JANUARY 2023

# Voice for Walcha's Group Submission to the Winterbourne Wind EIS

This Submission tables on behalf of the Community the Voice for Walcha's (VfW) **Group Objection** to the Winterbourne Wind Farm Project (WWF). The full reasons for the Community Objection are set out in the eleven (11) sub-submissions attached hereunder.

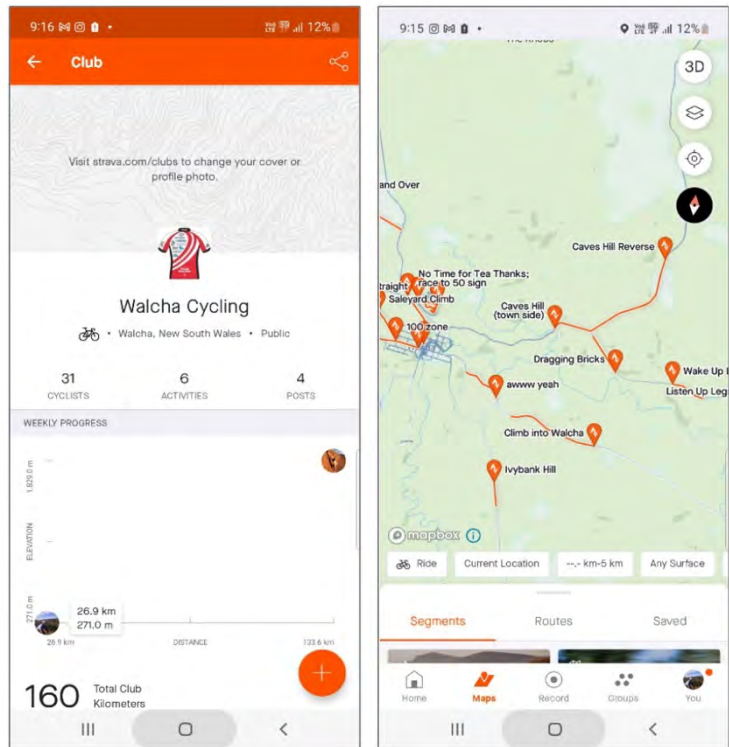
This intersection analysis is not appropriate to assess the traffic impacts east of Walcha.

Impact on Safety - The RTA Guide to Traffic Generating Development (as recommended by Transport NSW) recommends that “Where the accident history of a proposed transport route is presented, accident details (such as the type of conflict and vehicle involved) must be provided. Accident numbers alone are not sufficient for safety appraisal.”

The accident history has been provided but there are no details of vehicles involved. Given the high number of heavy vehicles that will be on the road as a result of the project, this omission is significant. How many of the accidents involved heavy vehicles?

Figure 2 Slope Analysis across the project

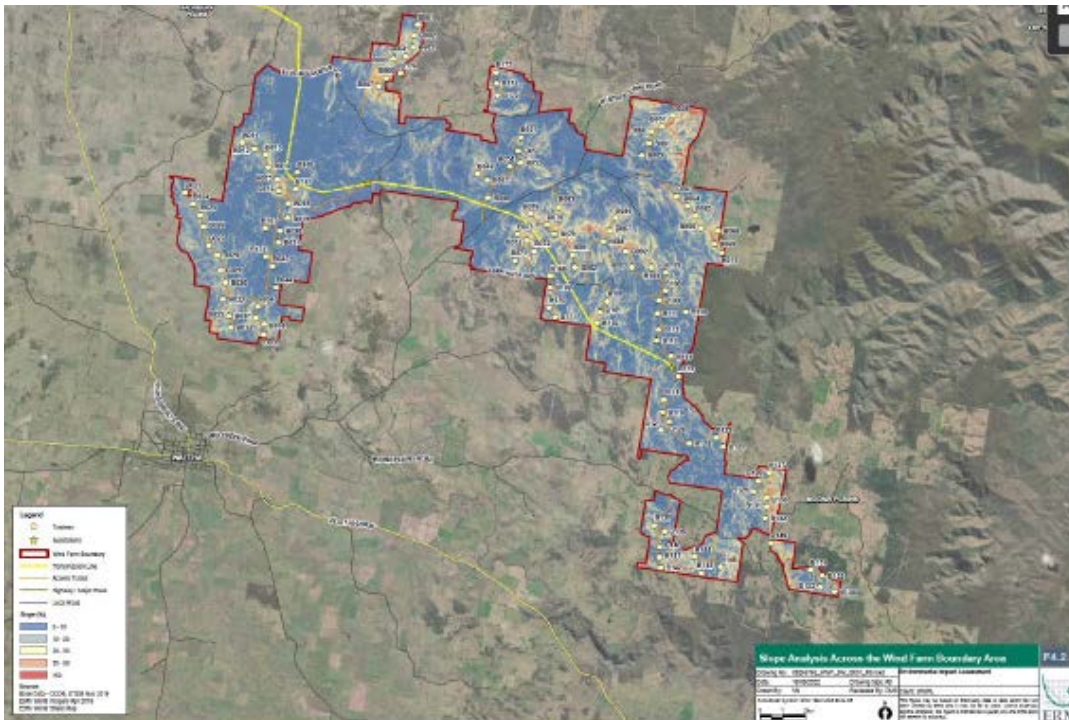
**2.1 Erosion** - as noted in our Soils and Water response, the erosion assessment (by RUSLE method) was carried out with the assumption that the project area was “on average” less than 10% grade. This assumption ignores the fact that the “Project Footprint” (being more relevant as this is where the earthworks will be carried out) is covering areas that are demonstrably greater in slope, as the roads lead up to the ridgelines where the turbines will be located. In these areas, the slopes are 10-20% at a minimum, with many roads and turbines located on areas that are 20-33%, with some clearly on slopes steeper than 33%, as noted in F4.2 of Appendix P – Soils and Water. This makes the “Moderate” assessed risk of erosion entirely inaccurate. The more accurate erosion risk assessment (by RUSLE method) of “Very High” is explained in our Soils and Water response.

While most of the Project Area is blue (<10% slope), by contrast, the area under most of the turbines is grey/blue, or yellow, indicating slopes of 10-20%, or 20-33%. For some turbines, and roads connecting them, they are clearly on areas shaded orange, indicating slope of 33%-50%.

“A slope analysis conducted to inform the project design confirmed that most of the Project Area consists of slopes of less than 10% (refer Figure 6-34). The Development Footprint (including turbine locations) tends to follow higher areas of the site which have steeper sided slopes.”
